**ADDENDUM #1
9-070425A**

April 17, 2007

Missouri Department of Transportation - 830 MoDOT Dr. – Structural Reinforcing and Total Structure Re-Roof

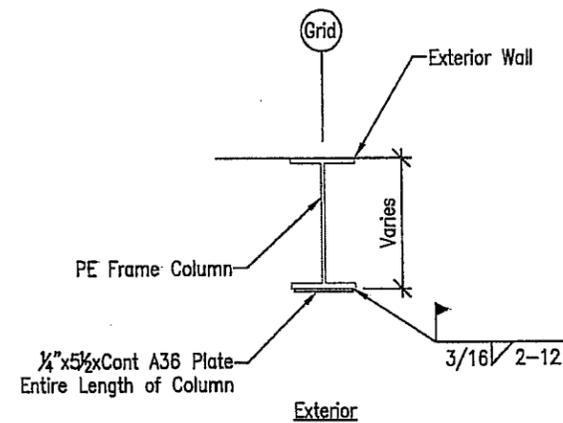
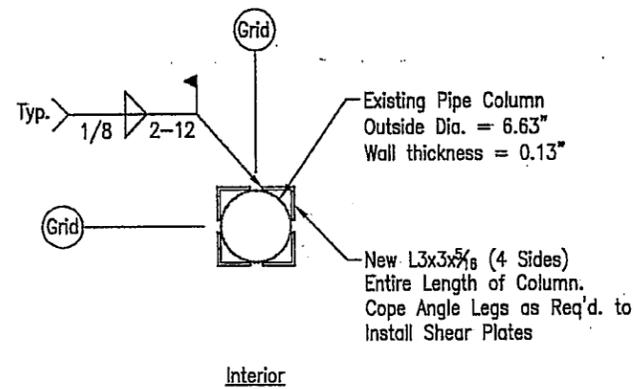
Sheet S101 See the revised partial S101 drawing attached.

8 Interior/Exterior Column Reinforcing
E2 3/4"=1'-0"

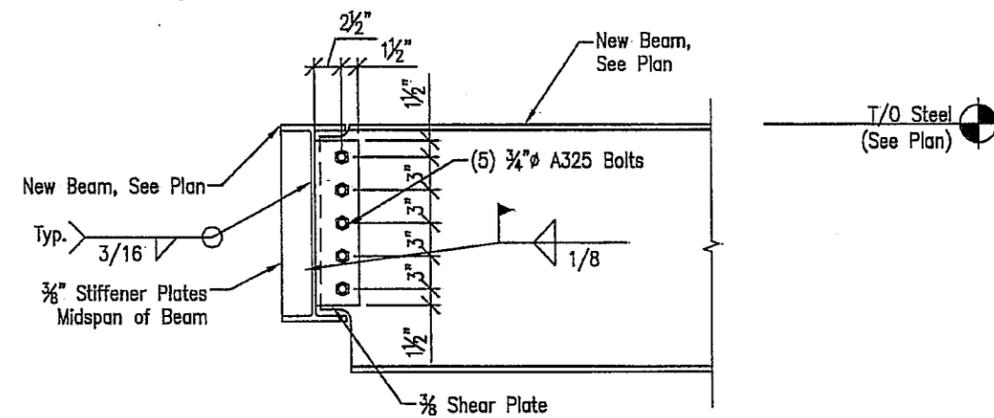
Detail 8/E2 See the revised detail 8/E2 attached.

- Notes for Exterior Column Reinforcing:
1. Grid AB Reinforce Column Full Height (Above and Below Mezzanine)
 2. Grid H Reinforce Column Only Above Mezzanine (Mezzanine Bears on Masonry)
